JLD-ISG-2016-01

Guidance for Flooding Hazard Focused Evaluation and Integrated Assessment

May 11, 2016

NEI 16-05 Flood Impact Assessment Process

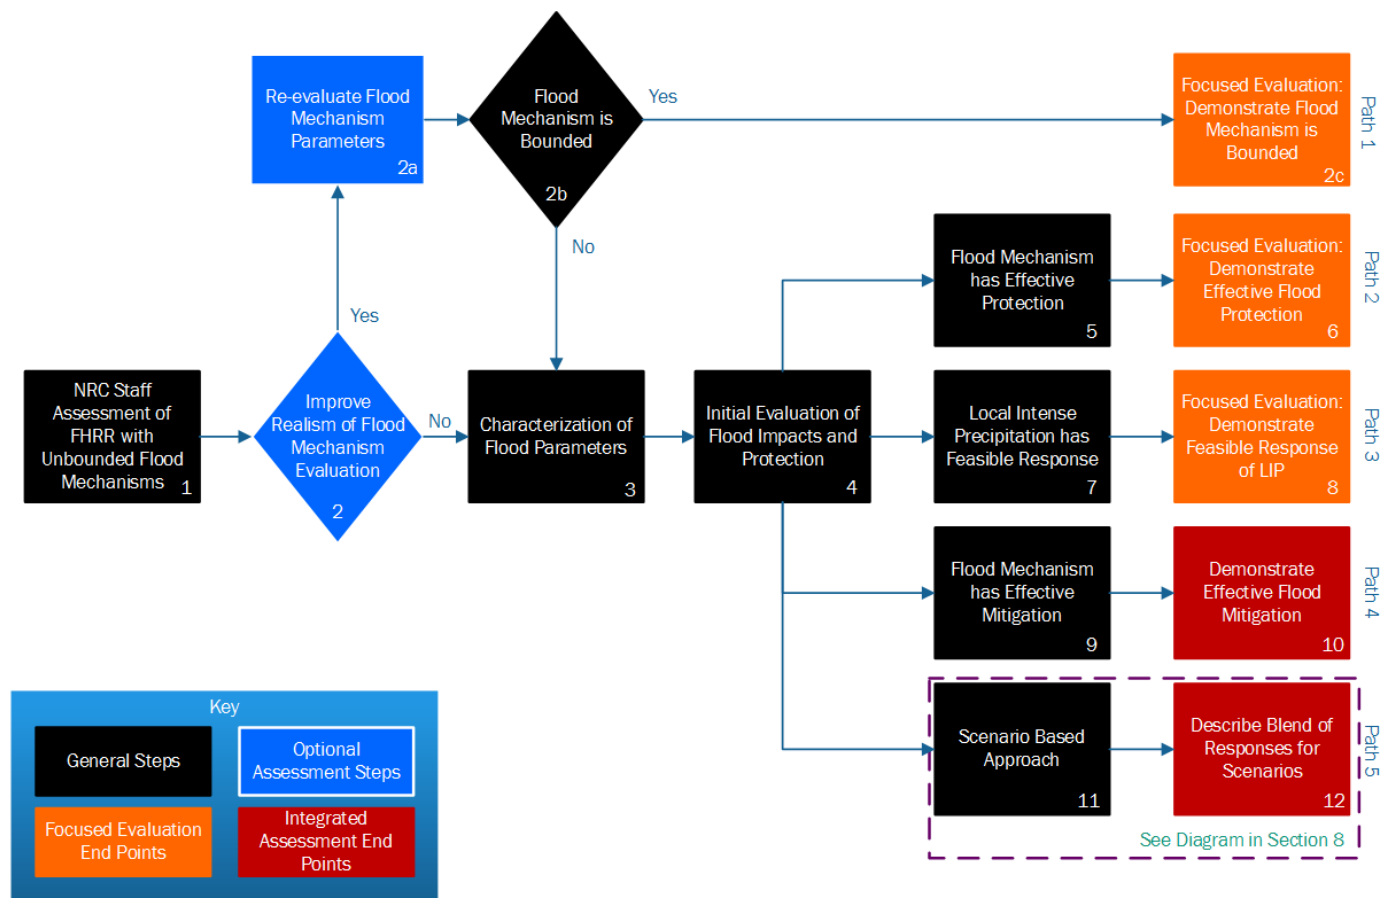
- NEI 16-05, Section 6.3.1 is acceptable

- NEI 16-05, Section 6.3.2 and Appendix B are acceptable with clarifications
 - The considerations of the December 23, 2013 RAI (ML13325A891) should account for the reevaluated flood parameters rather than the current licensing basis flood height
 - Reliability of temporary features should consider operating experience

NEI 16-05 Path 5 Detail

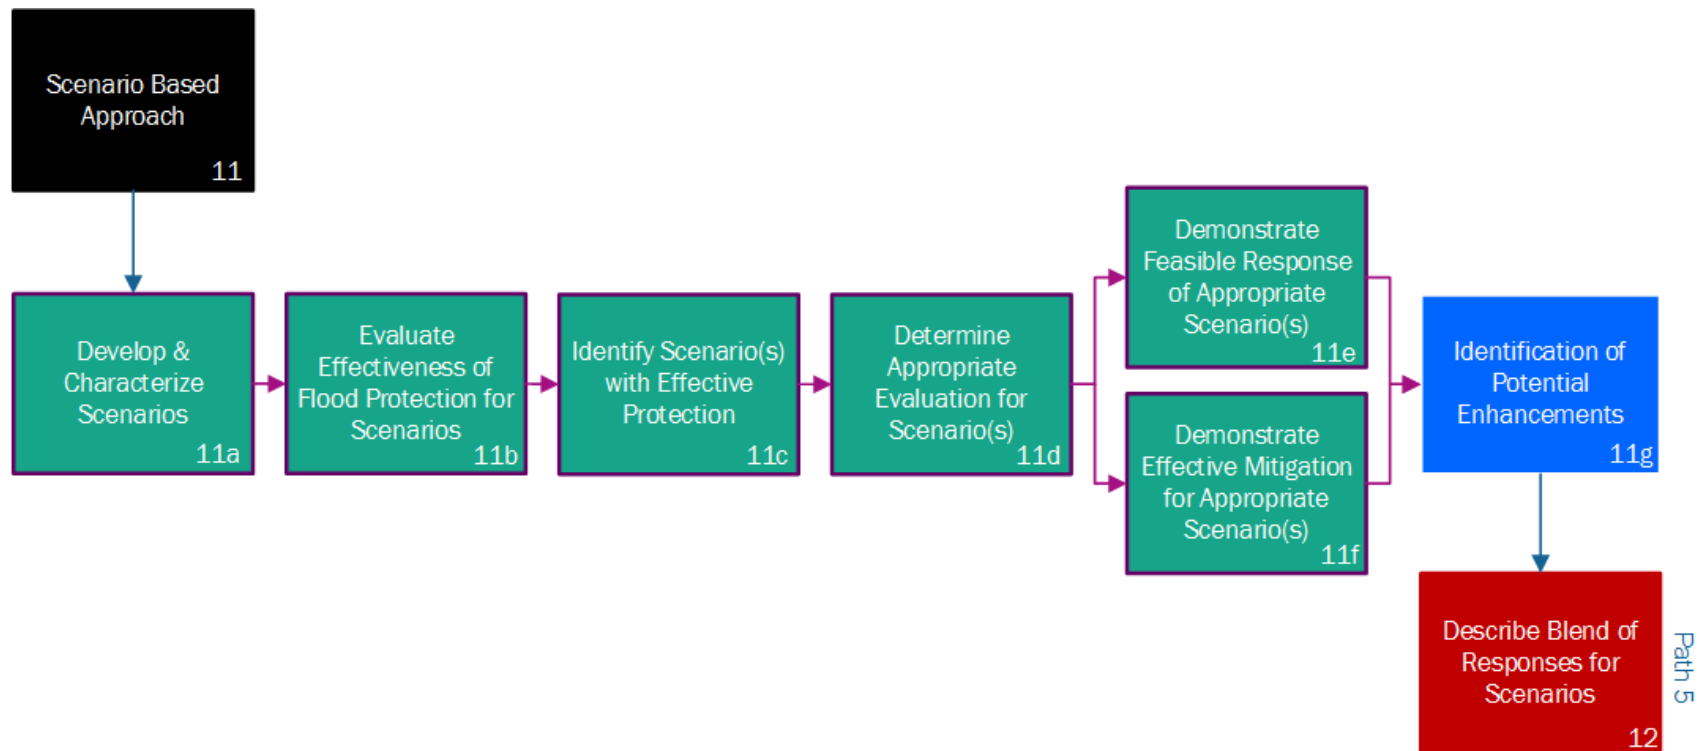
- NEI 16-05, Section 8.2 and App. D
- Scenarios developed should include critical flood elevations
- Identification of scenarios with effective flood protection should include path 2 considerations of NEI 16-05 and ISG
- Frequencies of exceedance should be developed with a methodology that conforms to App D, taking into account PFHA attributes and clarifications of ISG
